# HISTORIC PRESERVATION REVIEW BOARD STAFF REPORT AND RECOMMENDATION

Property Address:	611 Florida Avenue NW	(X)	Agenda
Landmark/District:	LeDroit Park Historic District	( )	Consent Calendar
		(X)	Concept Review
		( )	Permit Review
Meeting Date:	September 30, 2021	$(\mathbf{X})$	Alteration
H.P.A. Number:	21-413	( )	New Construction
		( )	Demolition
		( )	Subdivision

The applicant, BDP 01 LLC represented by Halil Ates, seeks concept review to replace a two-story rear wing with a three-story rear wing and partial fourth floor addition at 611 Florida Avenue NW. The existing house is a three-story contributing rowhouse in the LeDroit Park Historic District. Plans were prepared by Lee Design Studio of Falls Church.

Figure 1. Flag test mock-up of front façade of proposed fourth floor, August 31, 2021.

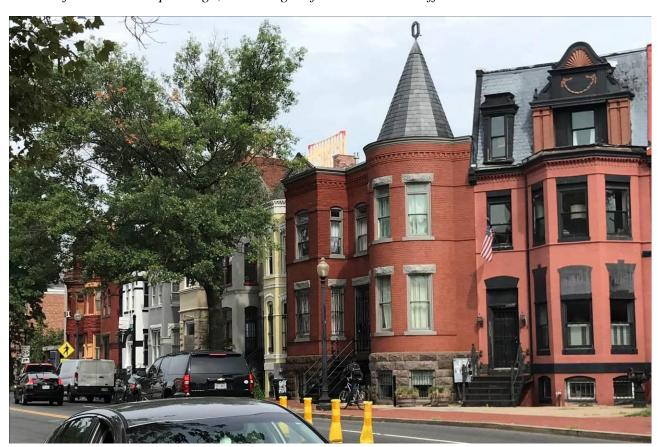
The addition was flag-tested by Staff (see Figure 1 below). The test showed that the front and east side of the penthouse would be clearly visible above the three neighboring two-story houses to the east (605, 607 and 609 Florida Avenue). The penthouse would be a plain contemporary form incompatible amongst the articulated roof forms of its neighbors. The penthouse would not be visible from directly in front of the house or from the west because the adjacent house on this side is an equivalent height to the subject property.

Additionally, the massing of an archetypal row house—with its tall main block and its shorter or equal height rear wing—should be considered in the context of LeDroit Park. No precedent for a rooftop addition taller than the main block of the house has been identified in this historic district. As a result, the historic district enjoys a level of integrity that protects its suburban views between and behind buildings from large roof top intrusions even on the rear of houses. The Board has regularly protected this characteristic of LeDroit Park by declining to approve rear or roof top additions that are taller than

The HPO recommends that the Review Board find the concept for a new three-story rear wing 611 Florida Avenue NW to be compatible with the character of the LeDroit Park Historic District, and consistent with the purpose of the preservation act, on the condition that the fourth-floor addition is removed from the concept design, and delegate final review to Staff.
